1963 Corvette: Service Bulletin: Transmission Shift Lever Vibration

Subject: Transmission Shift Lever Vibration
Model and Year: 1963 1000 Series, Chevy II and Corvette with Floor Mounted Shift Lever
Source: Chevrolet Technical Service Bulletin
Bulletin No: DR #595
Section: VII
Date: June 24, 1963

FIG. 1

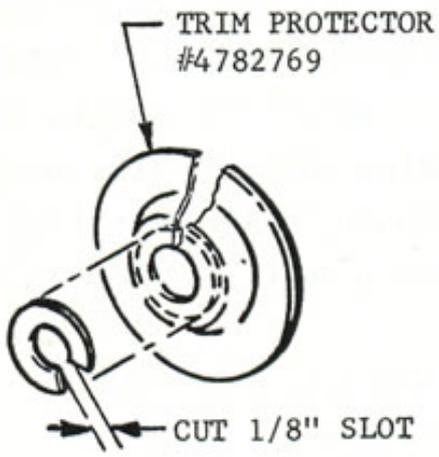
A plastic insulating washer, approximately 1" O.D., fabricated from trim protector No. 4782769 (see fig. 1, below) will be required on all vehicles produced prior to November 15, 1962, when a complaint of shift lever "buzzing" is encountered.

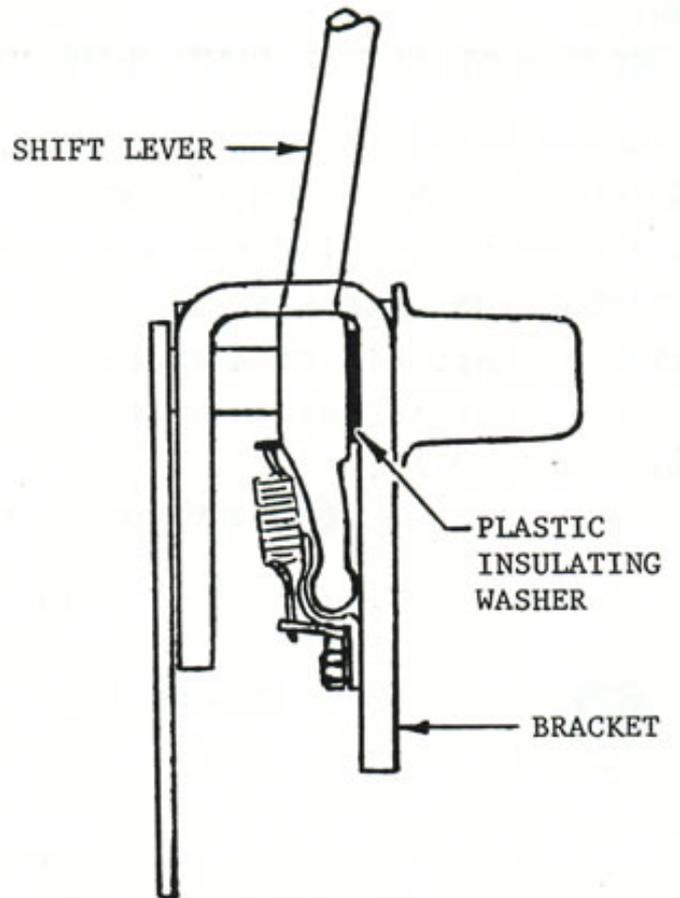
With the shift lever assembly removed from the vehicle, insert the above fabricated insulator washer on the shaft between the lever and bracket. (See Figure 2, below)

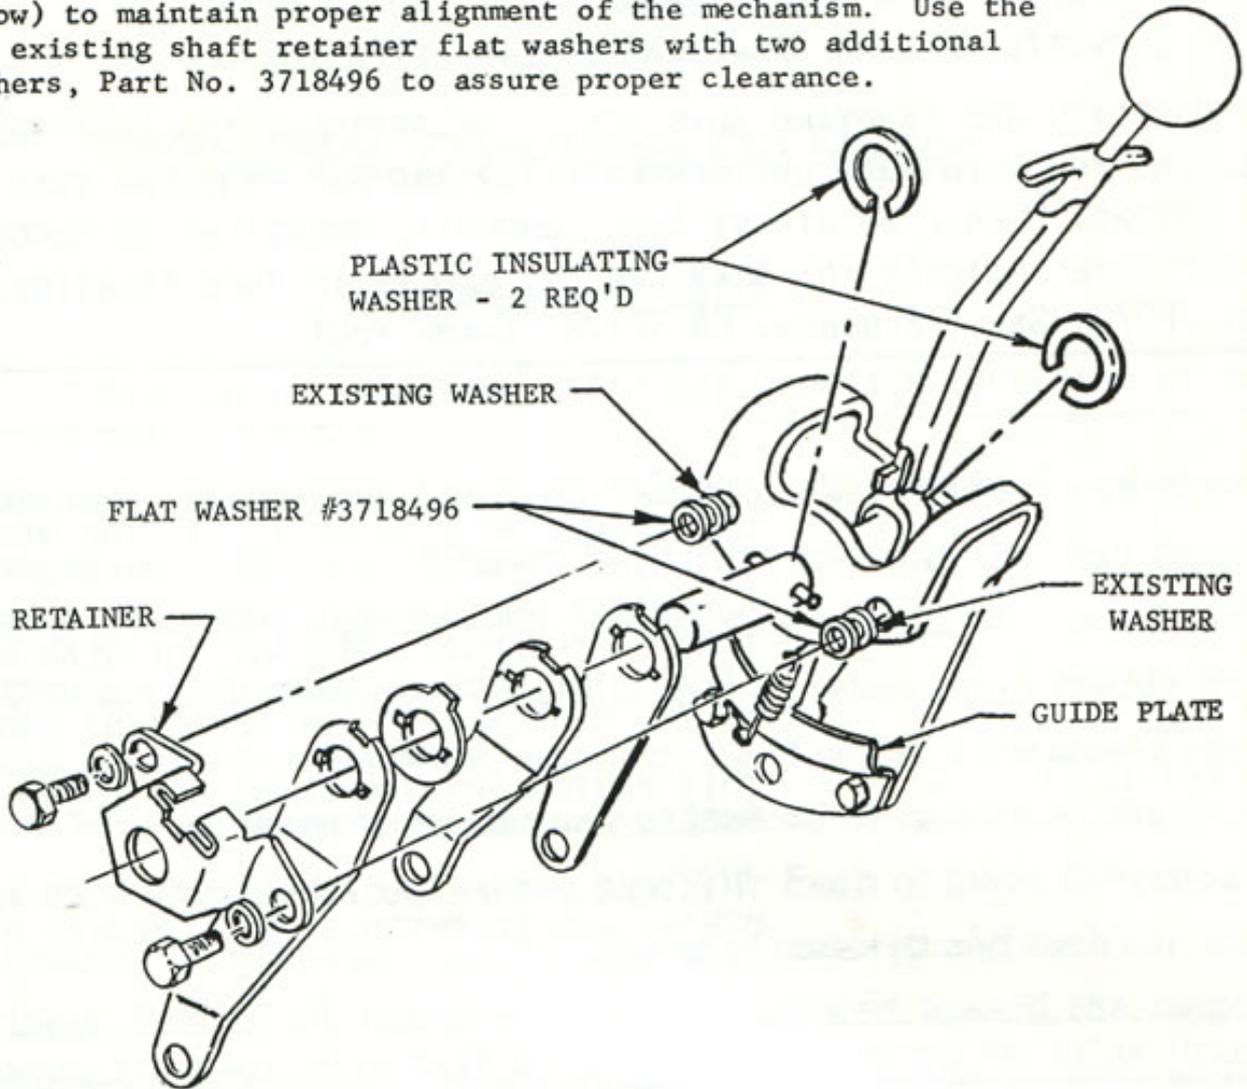
With the shift lever assembly removed from the vehicle, insert one insulator washer between the lever and bracket and another insulator washer between the bracket and pin, (See Figure 3, below) to maintain proper alignment of the mechanism. Use the two existing shaft retainer flat washers with two additional washers, Part No. 3718496 to assure proper clearance.
